SR 92 Improvements from US 41/SR 3/Cobb Parkway to Glade Road

Project Numbers: CSSTP-0006-00(862) and BRST0-0213-01(005)

Value Engineering Study Report Design Development Stage

March 2009

R-15

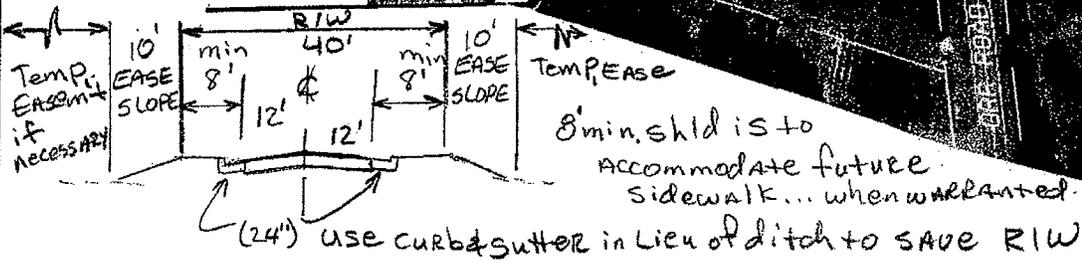
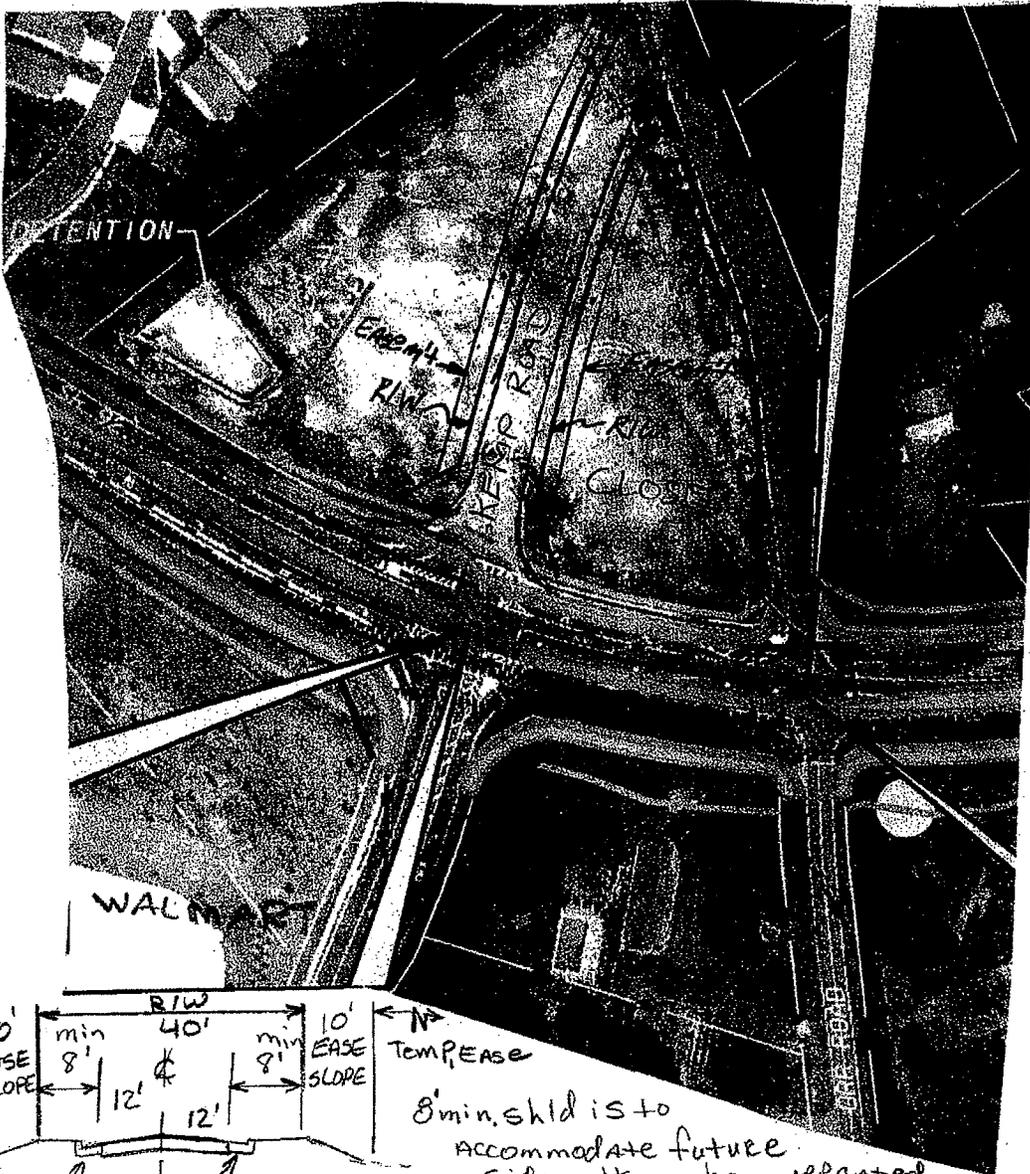
PROJECT:	SR 92 Improvements from US 41/SR 3/Cobb Pkwy to Glade Rd. P.I. Nos. 0006862 and 731865 <i>Cobb County, GDOT District 7</i> <i>Design Development Stage</i>	ALTERNATIVE NO.:	R-15
DESCRIPTION:	REALIGN ORR ROAD WITH KEMP ROAD AT THE MEDIAN OPENING	SHEET NO.:	1 of 4

ORIGINAL DESIGN

ALTERNATIVE DESIGN

SKETCH

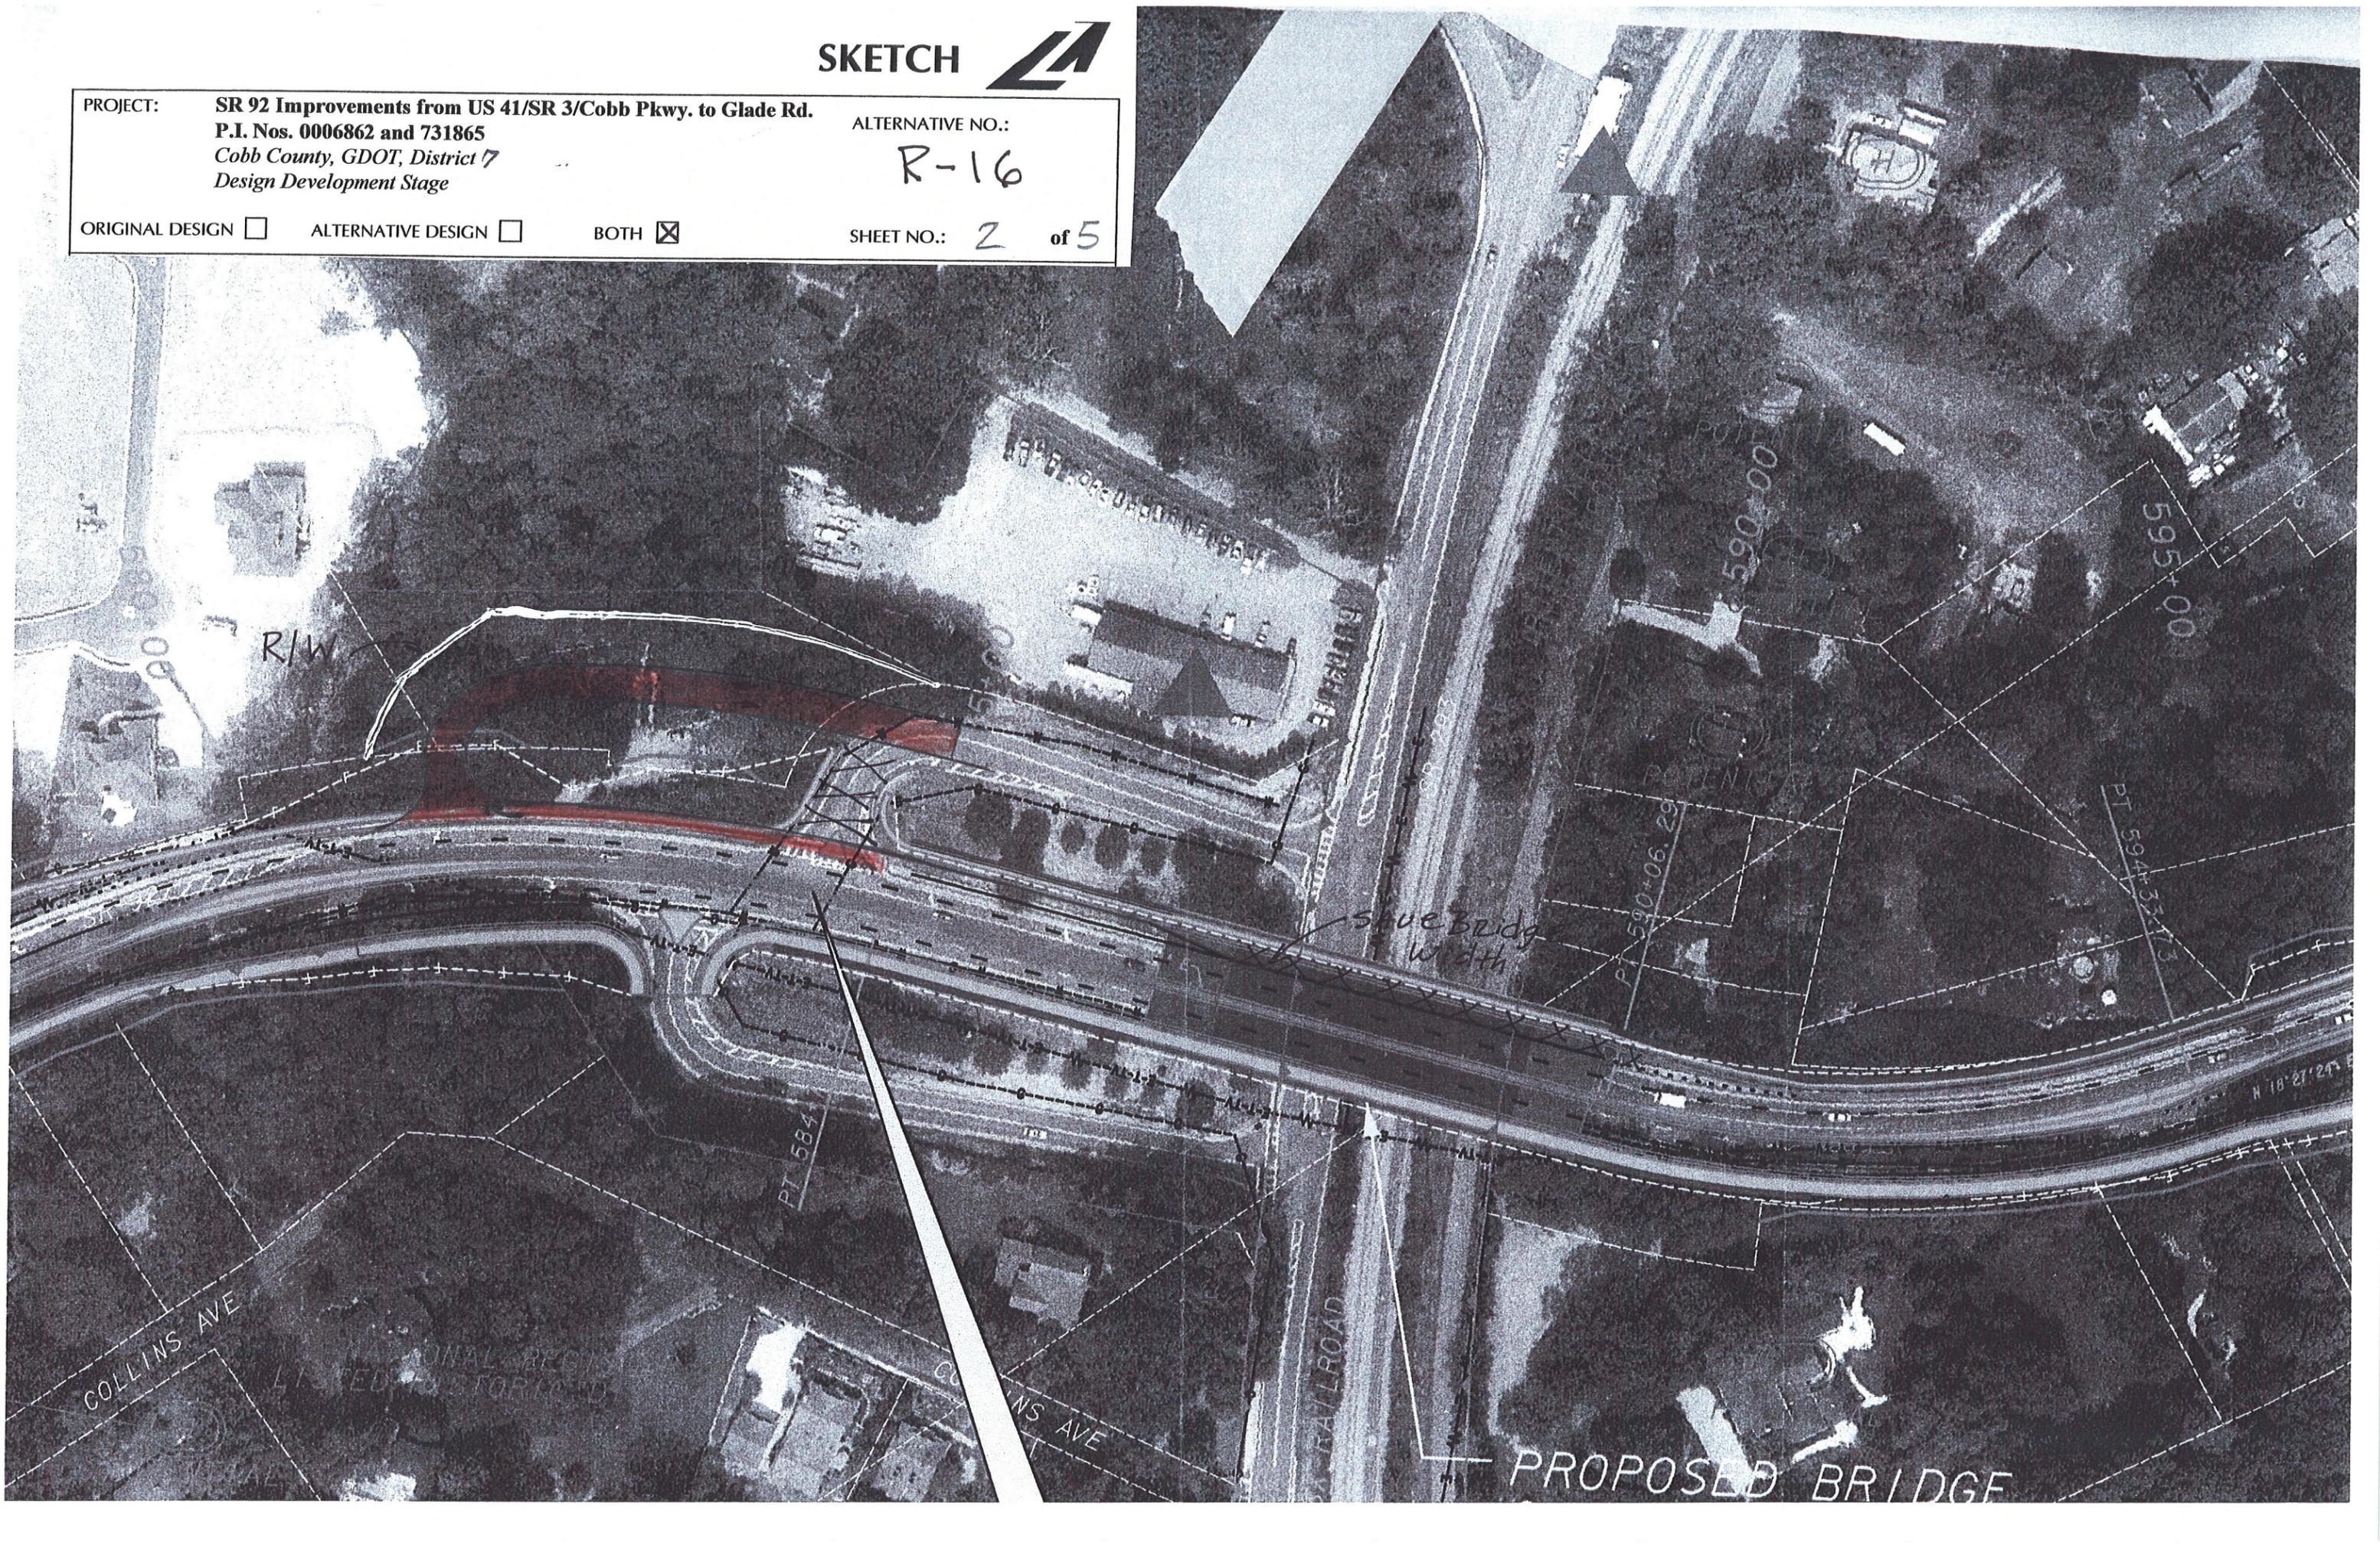
PROJECT:	SR 92 Improvements from US 41/SR 3/Cobb Pkwy to Glade Rd. P.I. Nos. 0006862 and 731865 <i>Cobb County, GDOT District 7</i> <i>Design Development Stage</i>	ALTERNATIVE NO.:	R-16
DESCRIPTION:	SHIFT THE RIGHT TURN ONTO NORTH MAIN STREET TO THE EAST TO ELIMINATE THE NEED FOR A FIFTH LANE ON THE BRIDGE OVER THE CSX RAILROAD	SHEET NO.:	1 of 5

ALTERNATIVE NO.: *B-1*

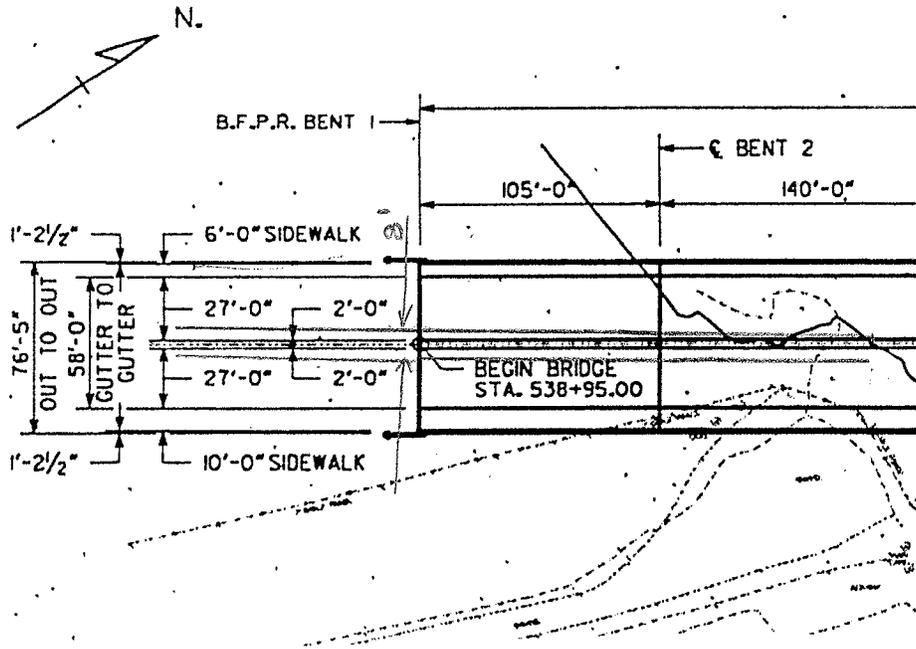
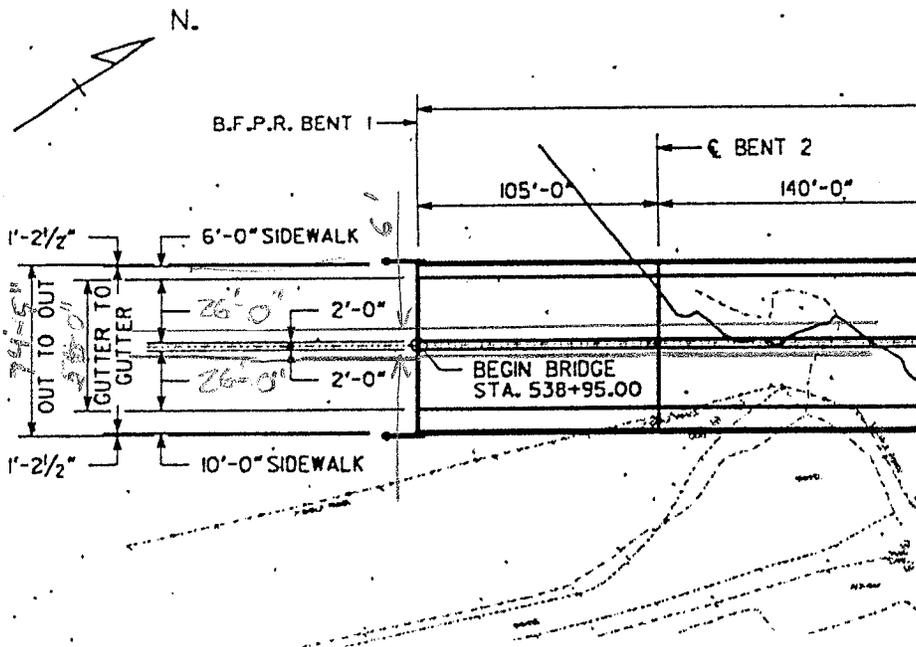
DESCRIPTION: **PROVIDE 6-FT-WIDE MEDIANS IN LIEU OF 8-FT-WIDE** SHEET NO.: **1 of 5**
MEDIANS ON THE 1,330-FT LONG BRIDGE

ORIGINAL

Proposed

ALTERNATIVE B-5
SHEET 3 OF 9
Proposed.

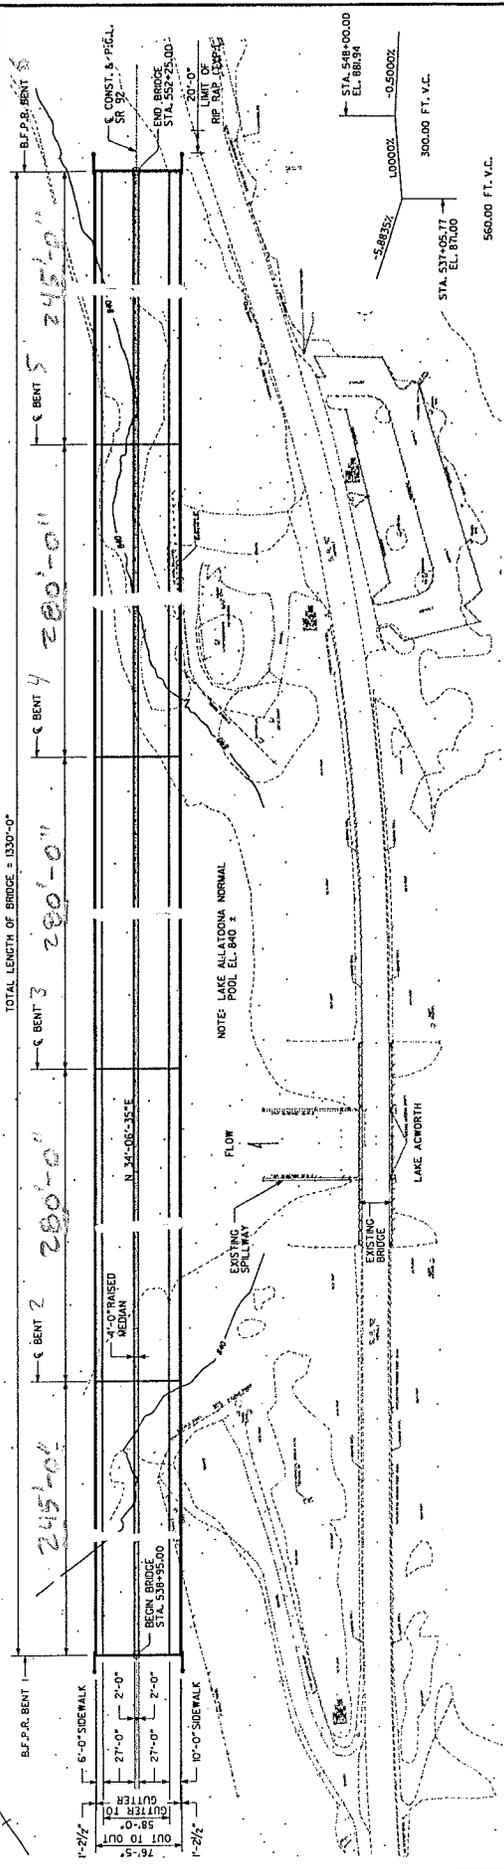
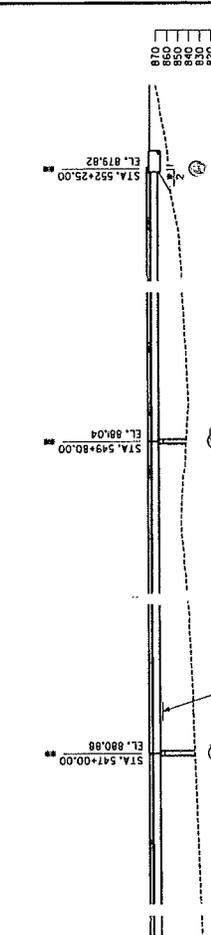
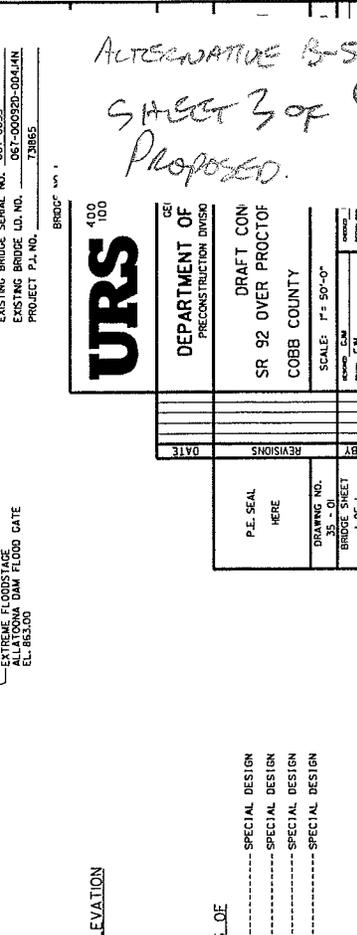
PROJECT: SR 92 Improvements from US 41/SR 3/Cobb Pkwy to Glade Rd. P.I. Nos. 0006862 and 731865 <i>Cobb County, GDOT, District 7</i> <i>Design Development Stage</i>	ALTERNATIVE NO.: B-5
DESCRIPTION: USE 280-FT-LONG STEEL THROUGH GIRDER SPANS IN LIEU OF 140-FT-LONG BULB TEES TO MINIMIZE STORAGE LOSS DUE TO BRIDGE PIERS	SHEET NO.: 1 of 4
